Safety Alert

Checking Nut on Stabilizer Control

Type:	CT
Model:	all except of CT-HL
Serial Number:	all aircraft built before September 2023
Applicable Countries:	not limited

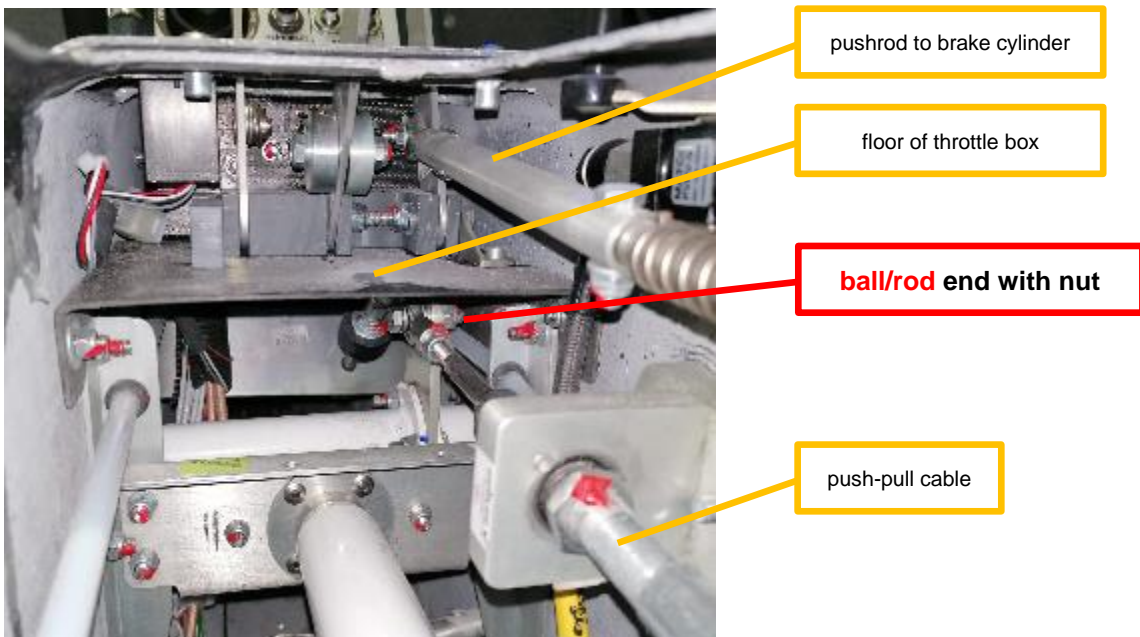
Open the rear cover of the center console. Take out the two hex bolts marked in red and loosen the two others marked yellow.

Identify the ball/rod end on the push-pull cable. The ball end is found underneath the throttle box.

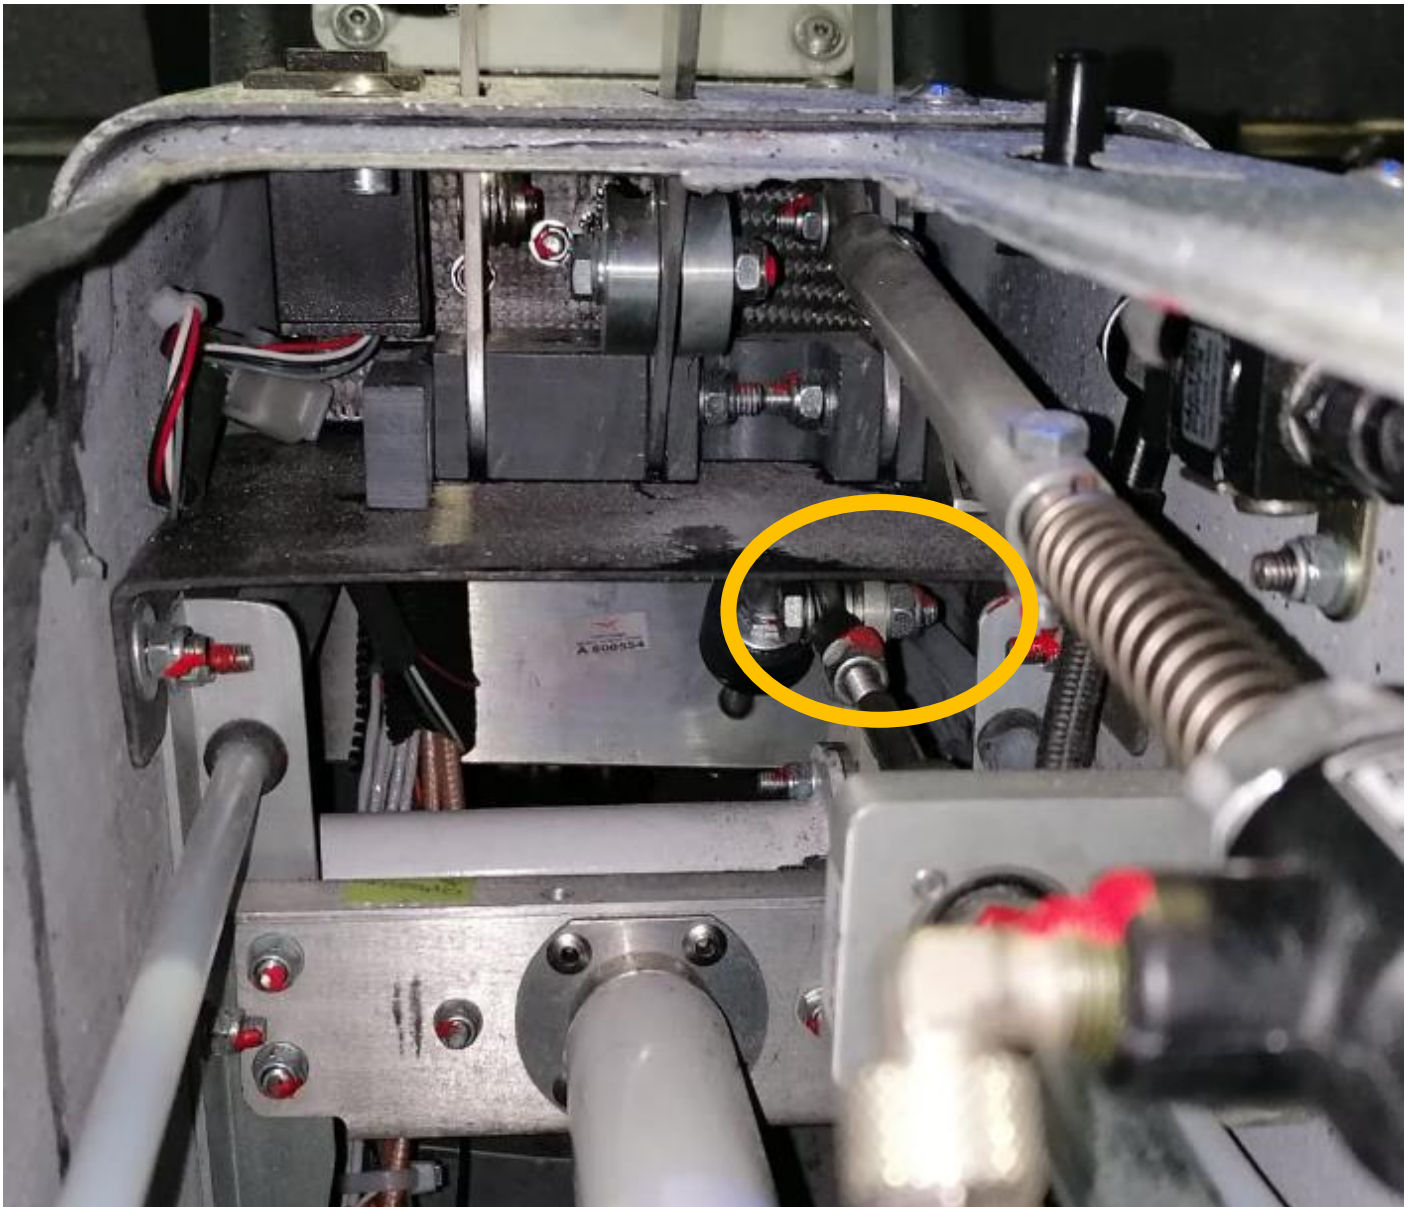
Use a flashlight and pull back the control stick. Check if the ball/rod end is correctly attached to the bell crank. See yellow marks in the picture below. A self-locking nut (nyloc stop nut) must be safely installed!

In the case a self-locking nut is safely installed, reinstall the cover of the center console make a logbook entry. Release the aircraft back to service in accordance with section 1.9.

In the case the nut is loose or a standard, non locking nut is installed, follow instructions of section 3.2.

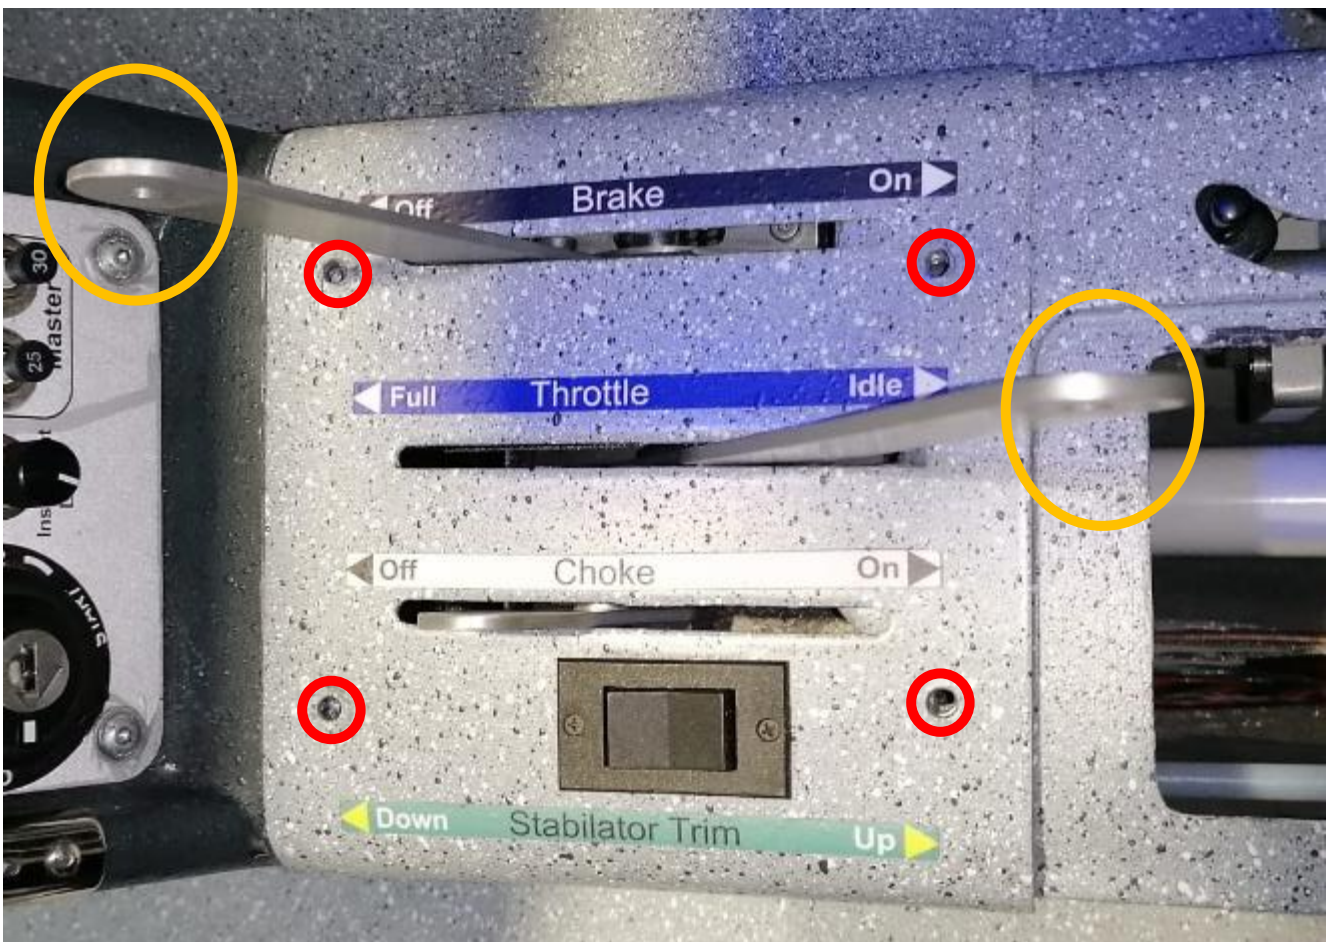
Uninstall the knobs of the power and brake lever marked in yellow. Take out the Allen screws attaching the cover of the throttle box marked in red (careful: two different lengths). In case an electric trim is installed, the switch shall be left installed to the cover.

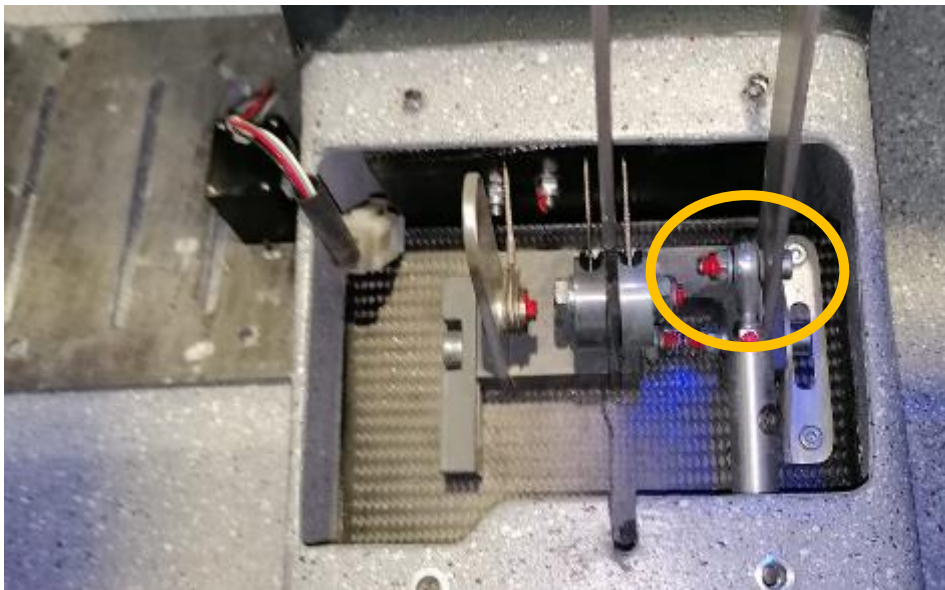
Lift the cover off the levers. In case an electric trim is installed, and put to the left side and attach it with tape to prevent the electric wires of the trim to rupture.

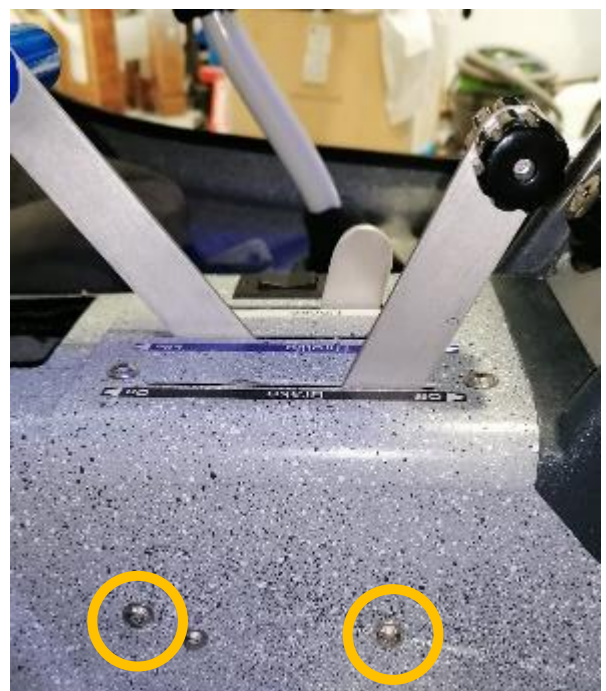
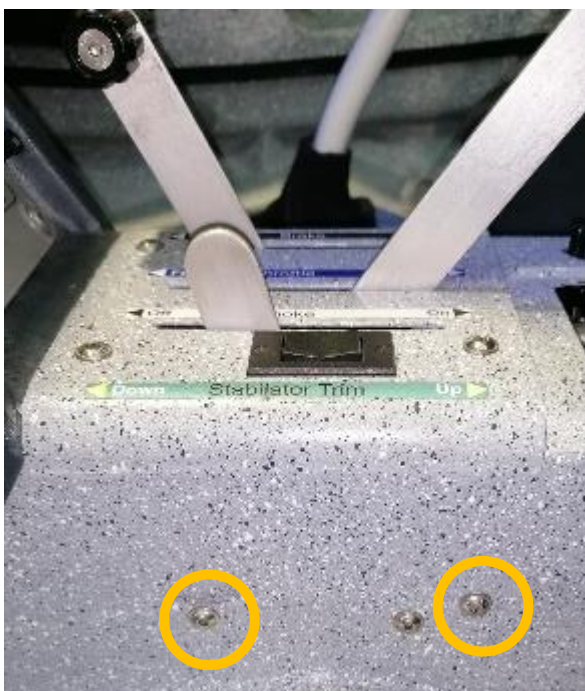
Uninstall the brake pushrod from the brake lever.

The levers are installed on the floor/base plate of the throttle box, which in return is bolted to the sidewalls of the center console. Uninstall them and lift the floor/base plate out of the throttle box.

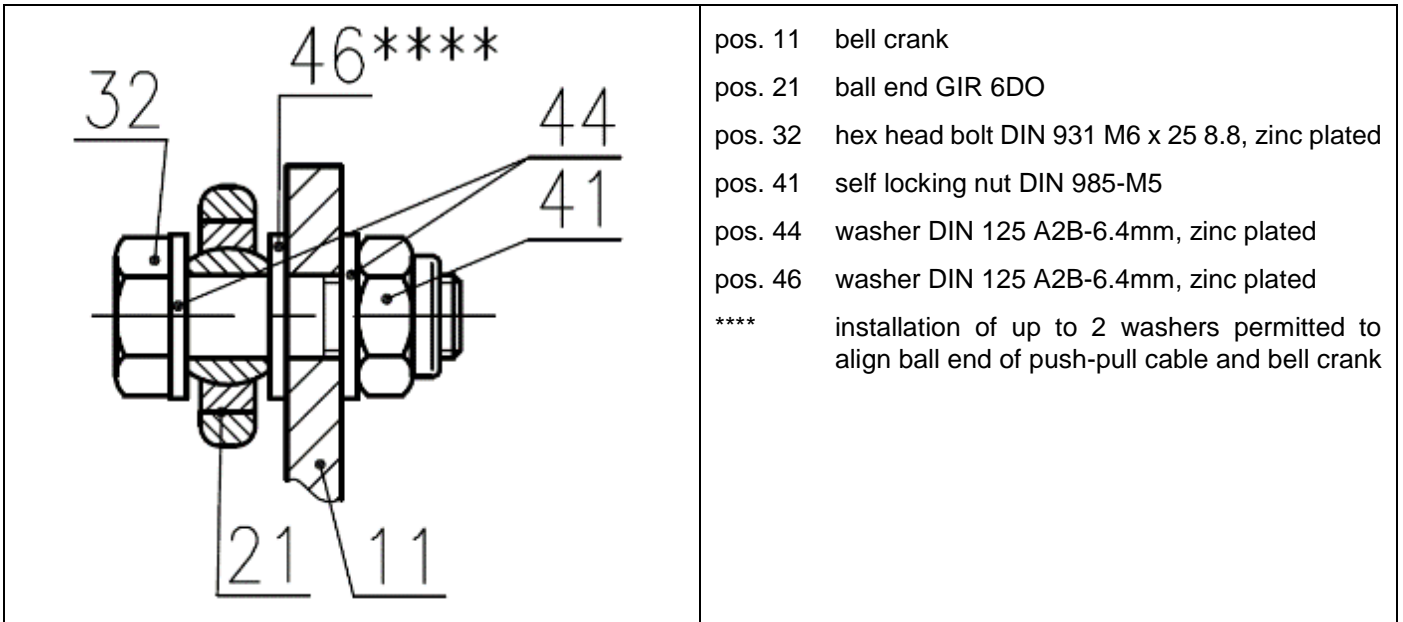
Install a self-locking nut (nyloc stop nut, DIN) on the bolt

Grease the ball-end, using heavy duty grease WGF 130, DIN 51502 or GLEITMO 800 by FLURO-Gelenklager GmbH. Reinstall floor of throttle box, power and brake lever and covers in reverse order or disassembly.
